ADDENDUM NO. 3

RE: HIGH SCHOOL #13

High School #13

Howard County Public School System
Bid Number: 016.20.B4

4 FIRE RATED SHAFT ENCLOSURE
A-033 SCALE: 1/2" = 1'-0"

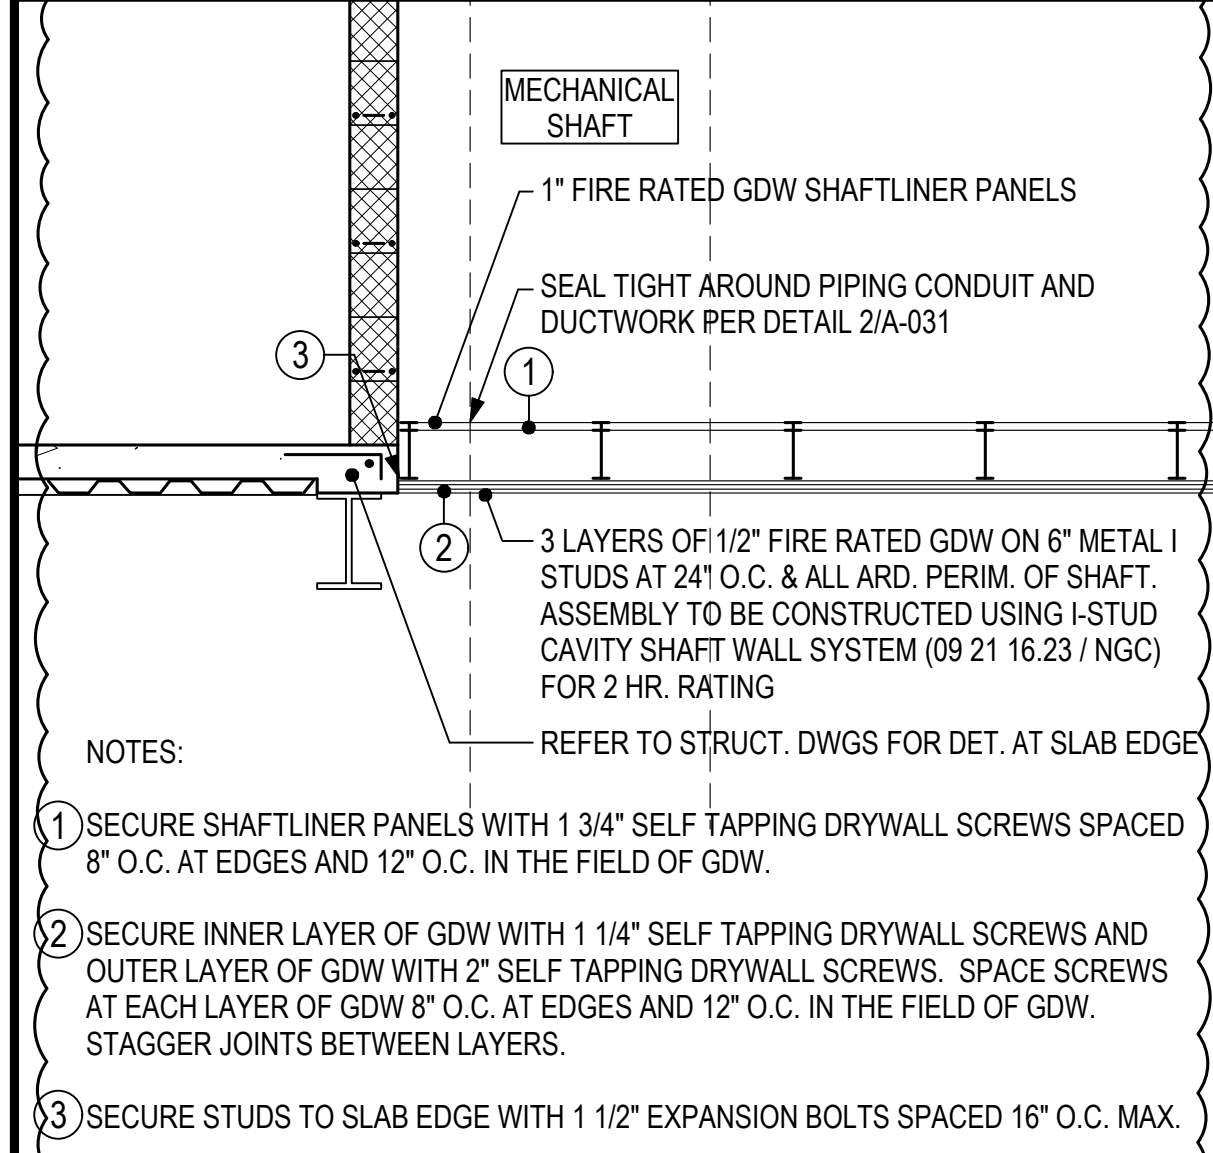
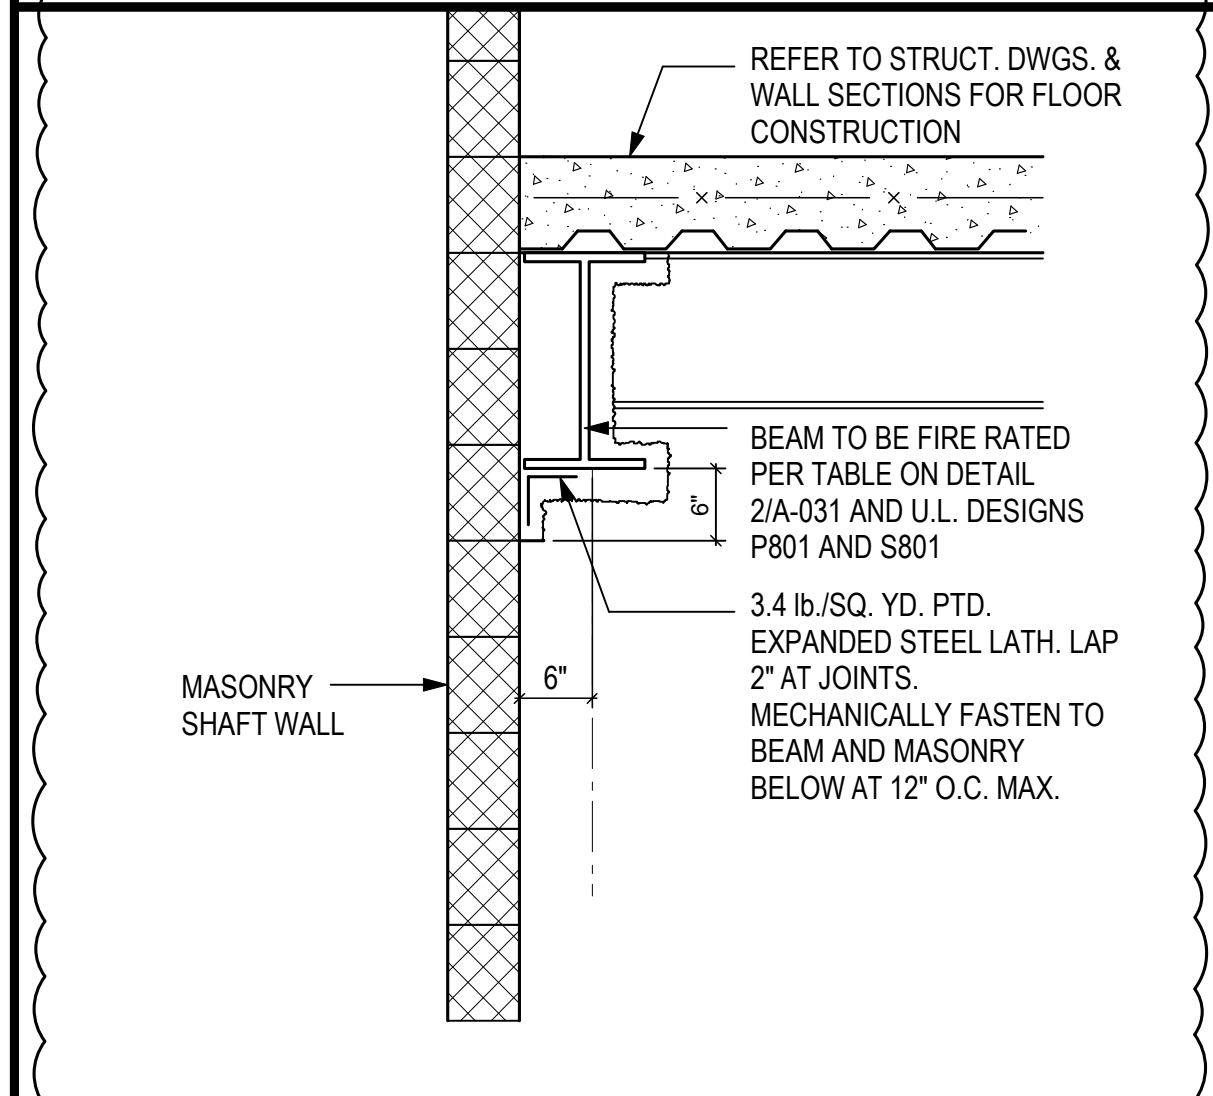
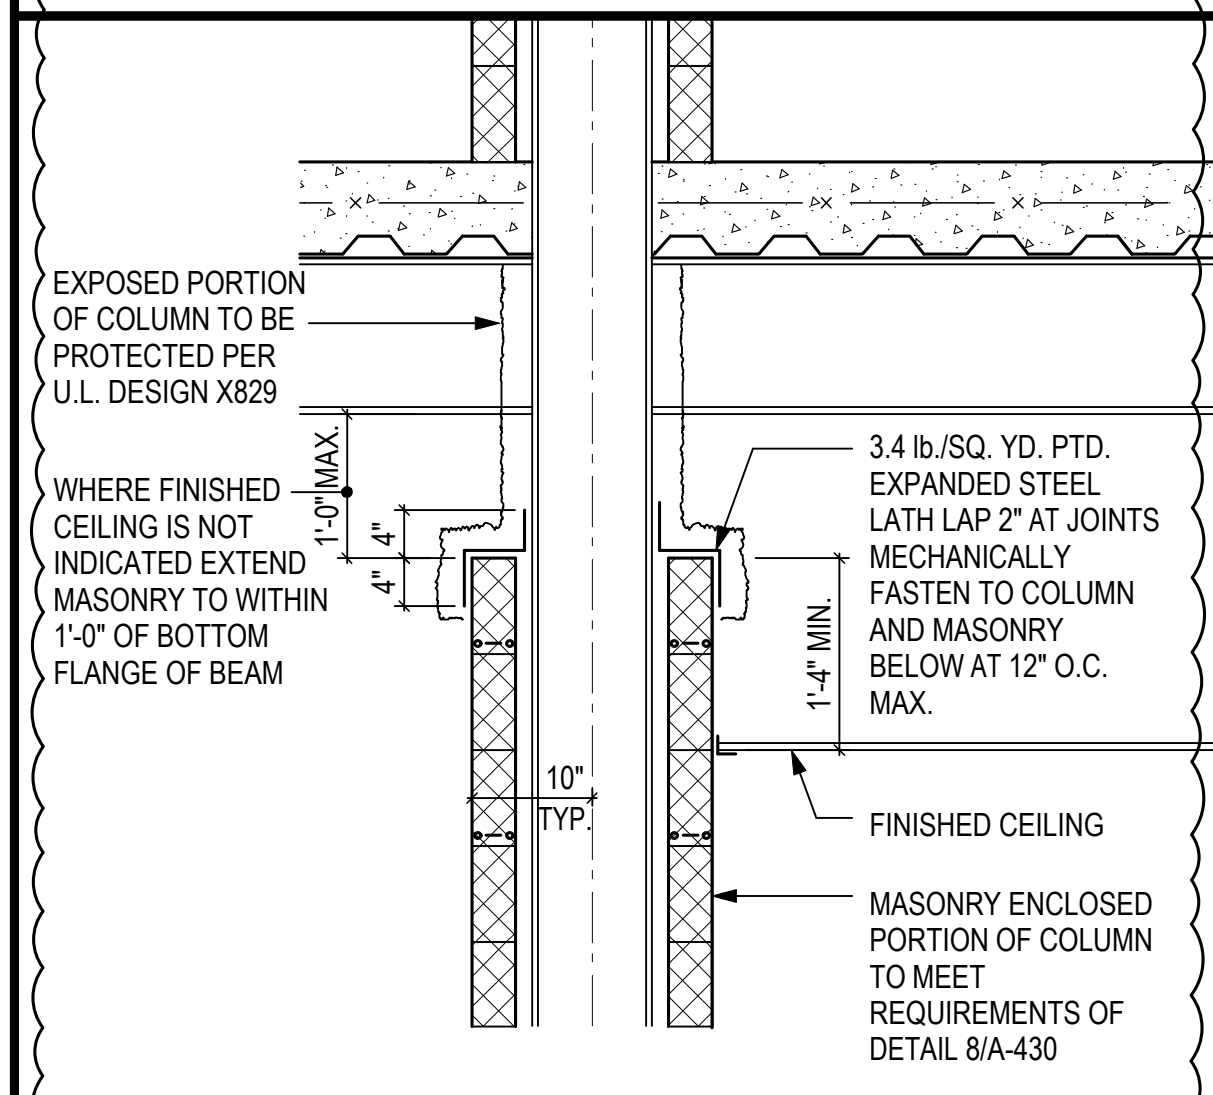
REVISE Detail 2/A-033 COLUMN FIREPROOFING DETAIL to reflect typical dimensions
REVISE Detail 3/A-033 BEAM FIREPROOFING DETAIL AT MASONRY SHAFTS to reflect typical relationship between beam and masonry wall
REPLACE Detail 4/A-033 FIRE RATED SHAFT ENCLOSURE
REVISE Spelling of Partition in Drawing Label

2 INSULATED TRANSLUCENT FIBERGLASS SKYLIGHT DETAILS
A-616 SCALE: 3" = 1'-0"

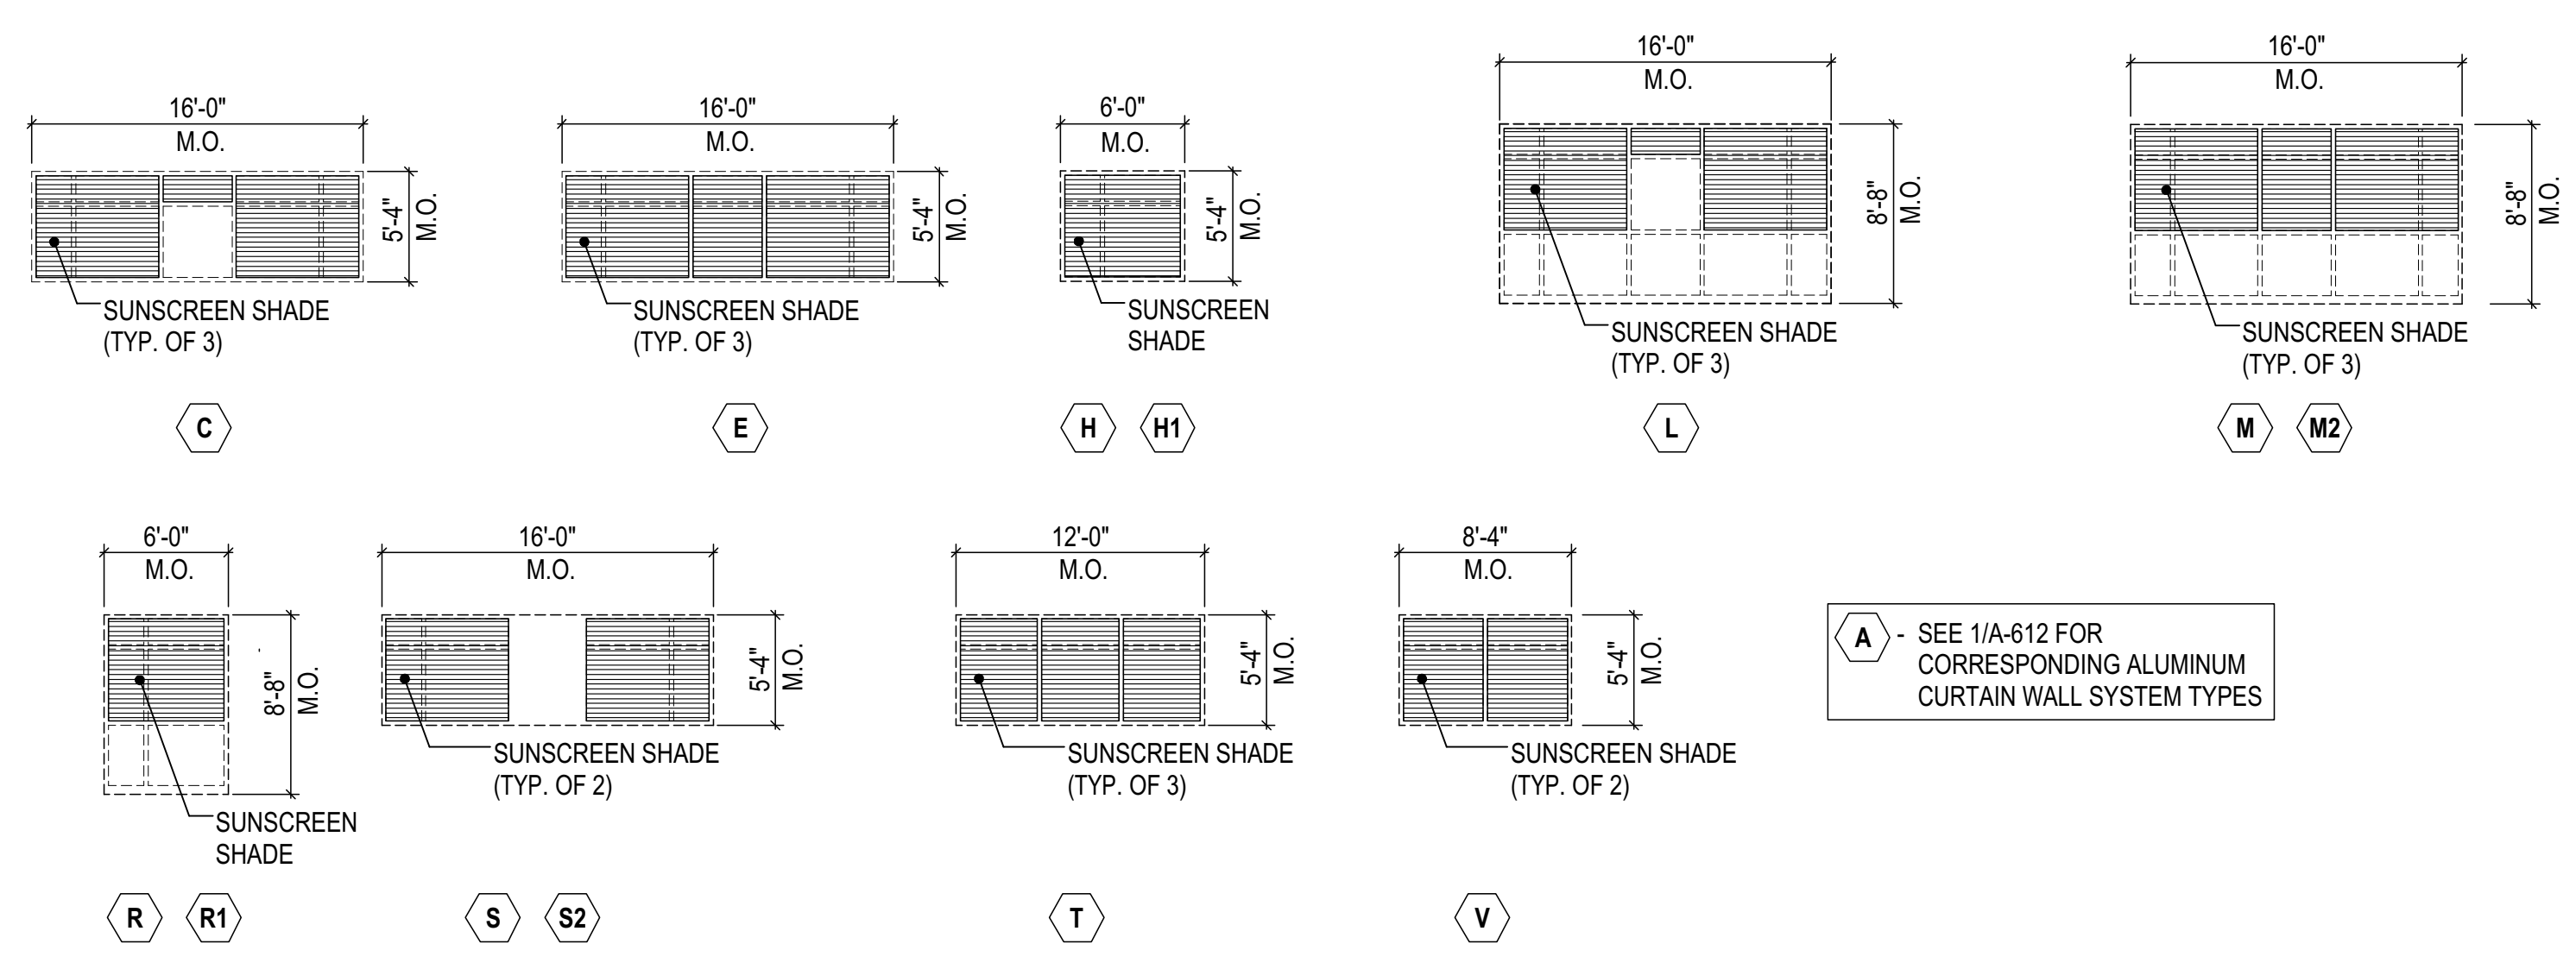
REVISE Details 2A and 2B to be coordinated with RCP and to show spray polyurethane foam insulation in lieu of batt insulation.

3 SUNSCREEN SHADE ELEVATIONS
A-616 SCALE: 1/8" = 1'-0"

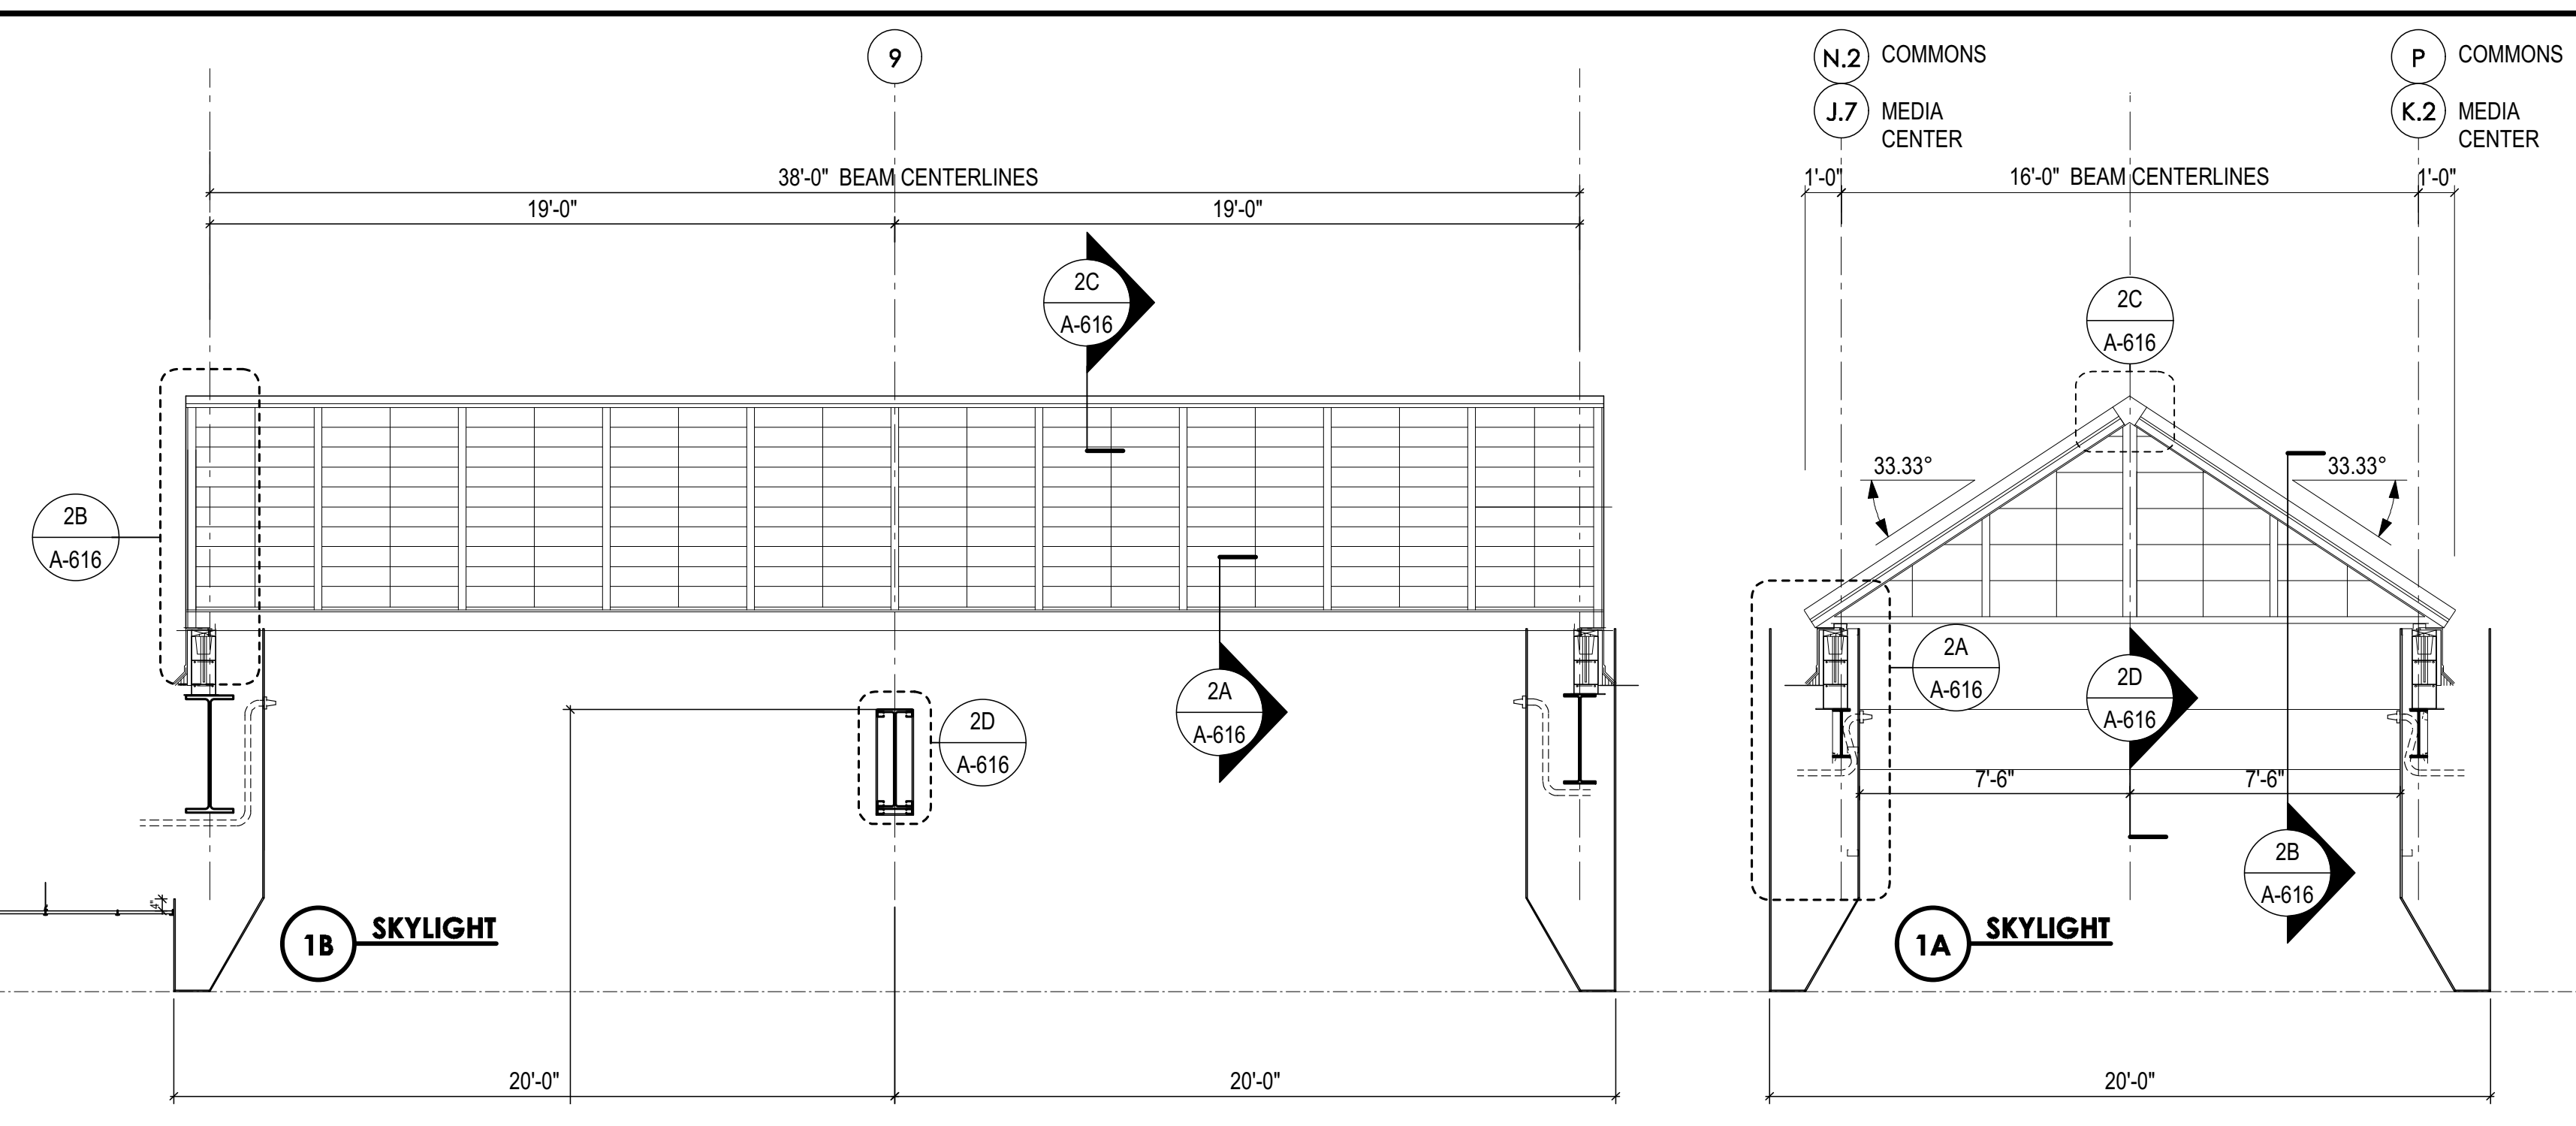
ADD Detail 3/A-616 SUNSCREEN SUNSHADE ELEVATIONS.
